**NUMBER:** 08-107-19 REV. A

**DATE:** November 9, 2019

Positive Generator Battery Cable Location Re-Route

2019 (BV) Jeep Renegade

**Fig. 1**  
**Generator Positive Cable**

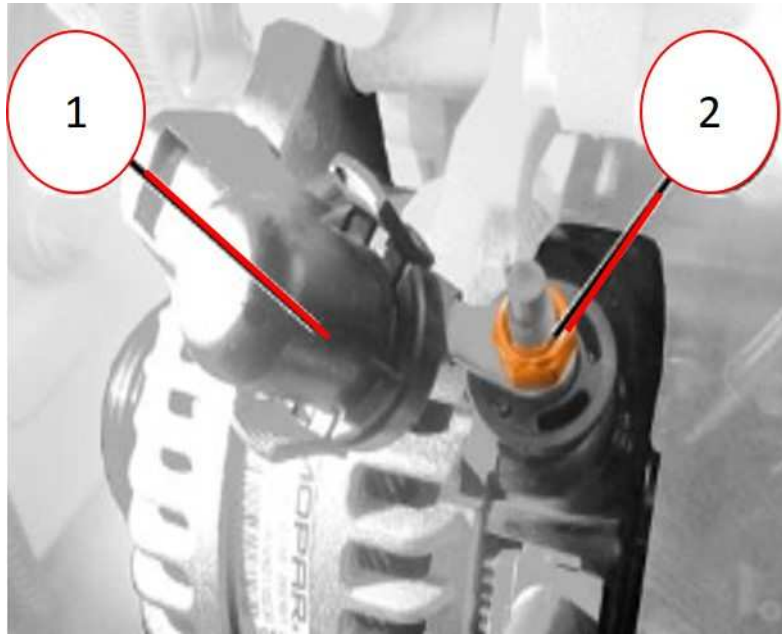
- Remove the protective cap and remove the nut for the battery positive electrical connection at the generator (Fig. 1).

- Connect the positive battery cable to the generator, then tighten the positive battery nut to 15 N·m (133 in. lbs) (Fig. 1).
- Connect the negative battery cable. If equipped with an Intelligent Battery Sensor (IBS), connect the IBS connector. Refer to the detailed service procedures available in DealerCONNECT> Service Library under: Service Info> 08 - Electrical / 8F - Engine Systems / Battery System / Cables, Battery / Removal and Installation> Negative Cable.
- Cycle the ignition ON/OFF/ON.

**Fig. 2**  
**Generator Cable Re-routing Position**

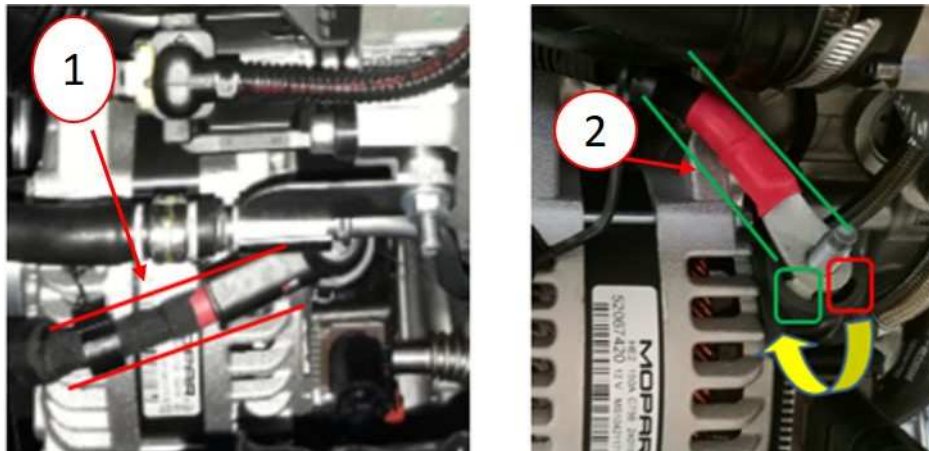
The generator positive battery cable may come into contact with the generator drive belt pulley.

- Re-route the generator positive cable as shown (Fig. 2).
